RE: Hickory Creek Estates – Development Plan
CEC Project 152-743

Civil & Environmental Consultants, Inc. (CEC) has received the review comments prepared by the City of Grove City, dated September 16, 2015, for Hickory Creek Estates – Development Plan, and has prepared the following responses.

CITY OF GROVE CITY, OHIO DEVELOPMENT PLAN HICKORY CREEK ESTATES

DRAWING NO.: **C000**
COVER SHEET SHEET 1 OF 7

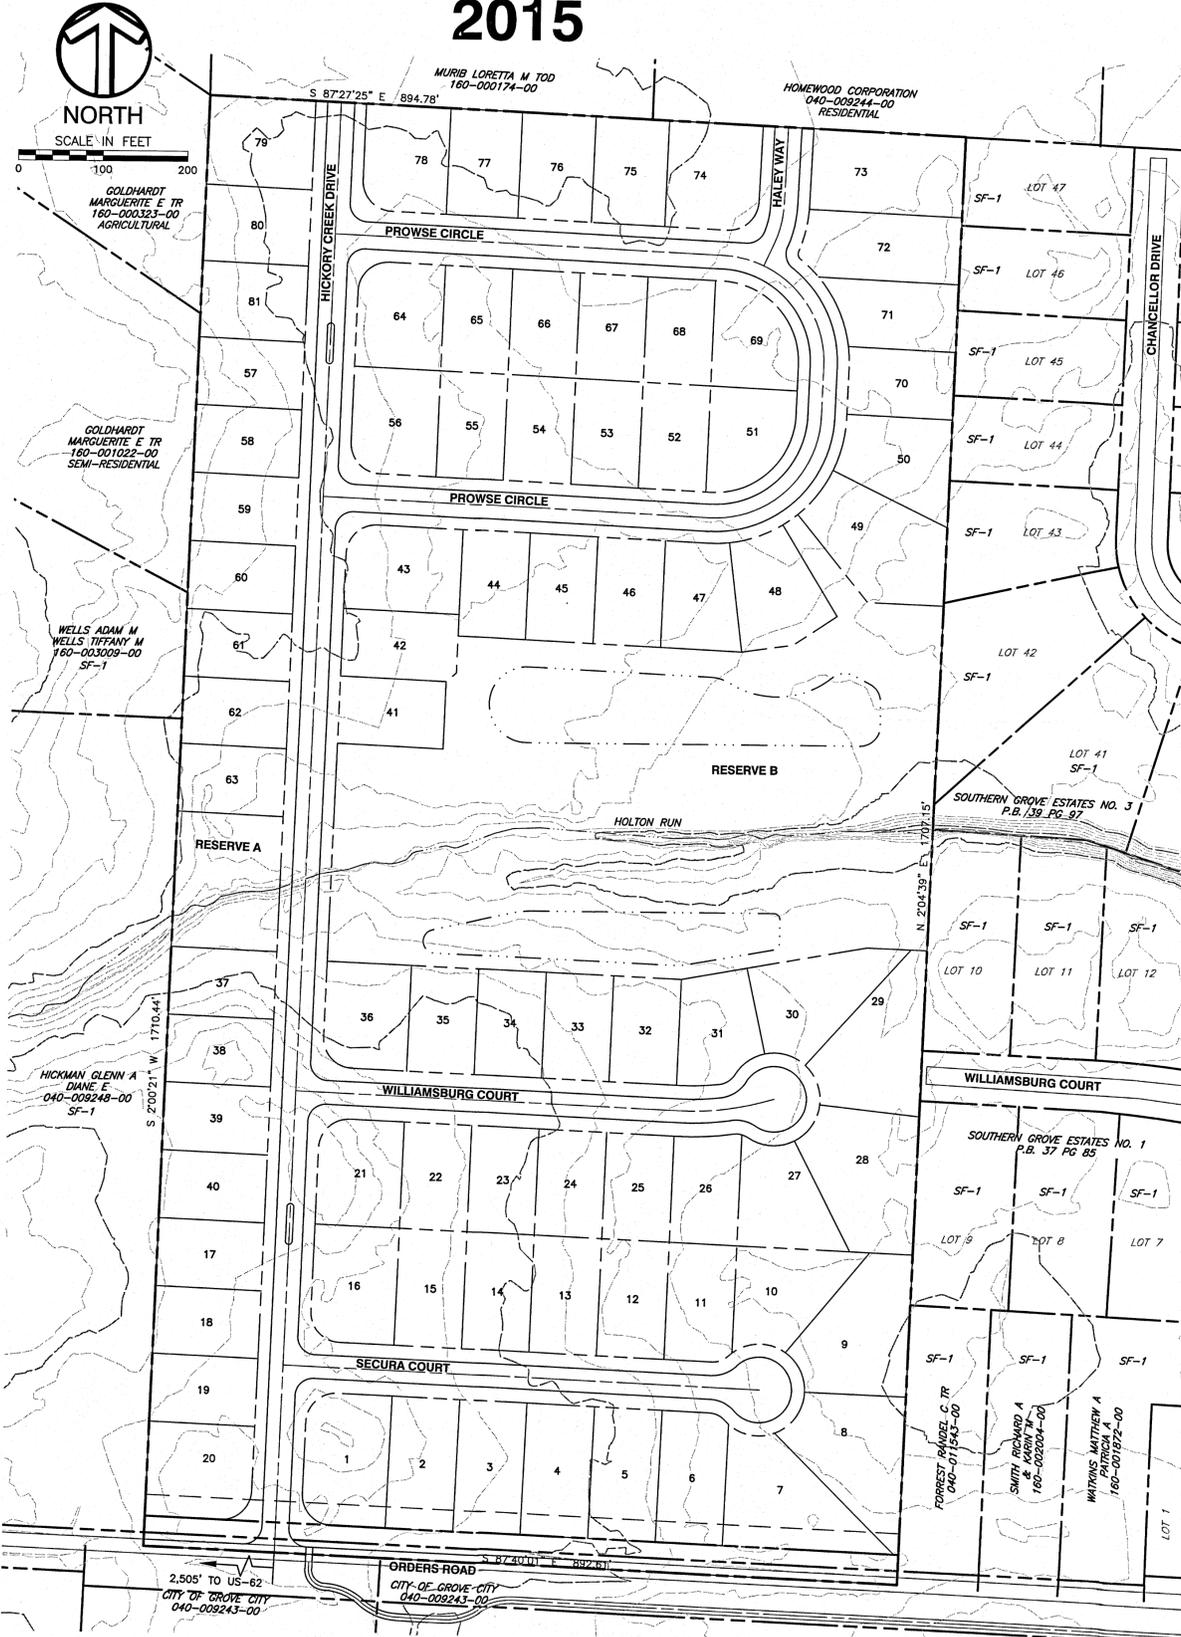
9. Property dimensions and approximate distance to nearest cross street added to Cover Sheet.
10. Existing zoning of adjacent parcels has been added to relevant plan sheets.
11. All rezoning references removed from Development Plan materials.
12. Design and spacing of driveways provided on Sheet 7: Details

LANDSCAPE PLAN

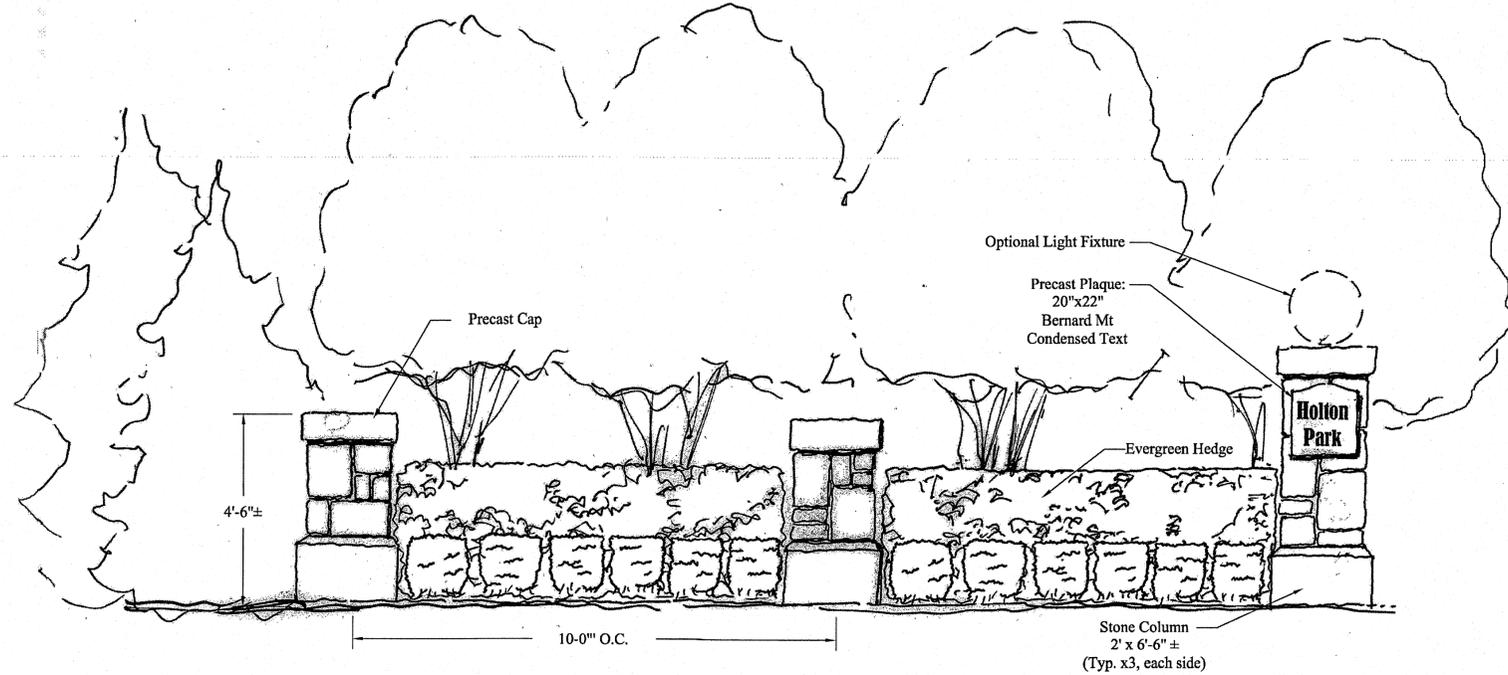
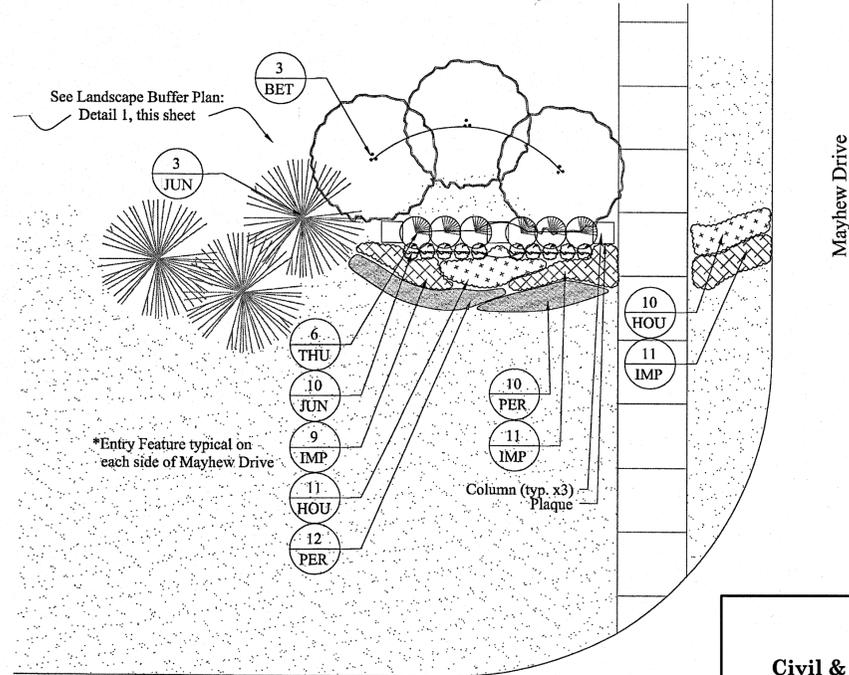
18. A note has been added to sheet 6.
19. A note has been added to sheet 6.
20. Details have been revised to show 50%.
21. A note has been added to sheet 6 in the Landscape Buffer detail.
22. A note has been added to sheet 6.
23. JNS callout changed to JUN, the callout for Wichita Juniper.
